Service Bulletin

Bulletin No.: PIT5312

Subject: Steering Column Grind Pop Bind Noise And/Or Feeling When Turning

Models: 2015 Cadillac Escalade Models
2014 Chevrolet Silverado 1500
2015 Chevrolet Silverado, Suburban, Tahoe
2014 GMC Sierra 1500
2015 GMC Sierra, Yukon Models
With Tilt and Telescoping Steering Column (RPO N38 or N37)
Built Before August 12, 2014

3924680

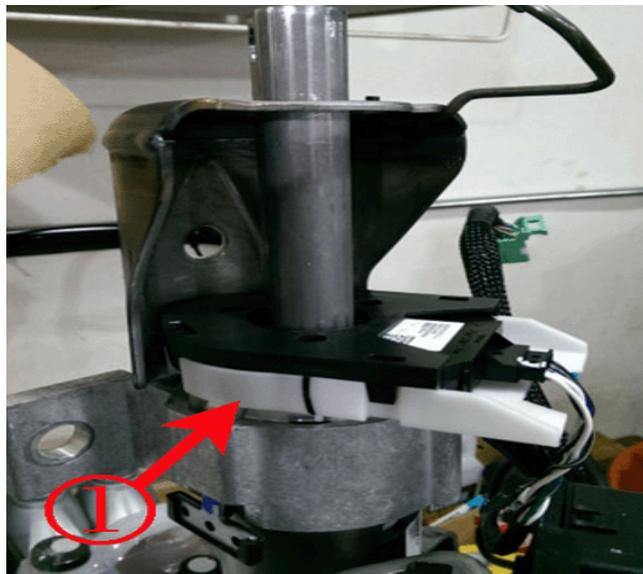
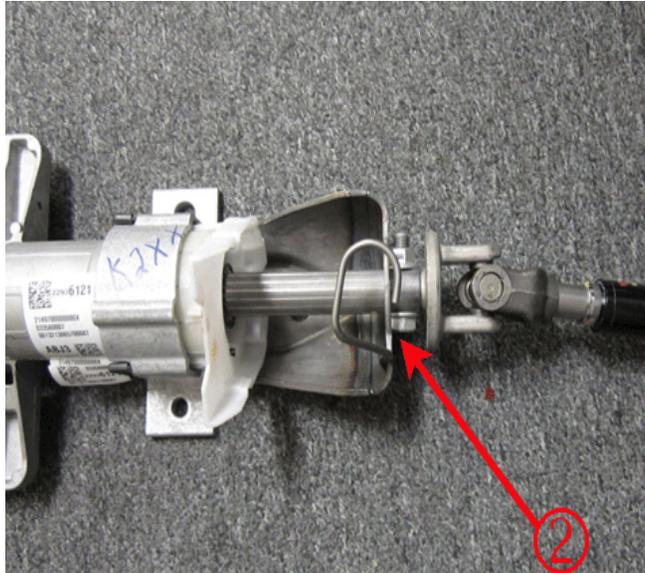
Some owners may comment on a grind, pop or bind feeling/noise in the steering column when turning left or right. This concern could be caused by either of the following:

1. The lower column bearing (1) may be out of position. The 1st picture shows the lower column bearing (1) in its correct position, while the 2nd picture below shows the lower column bearing out of position.

Note: Do Not repair the steering column for these conditions.

Replace the steering column assembly to correct either condition
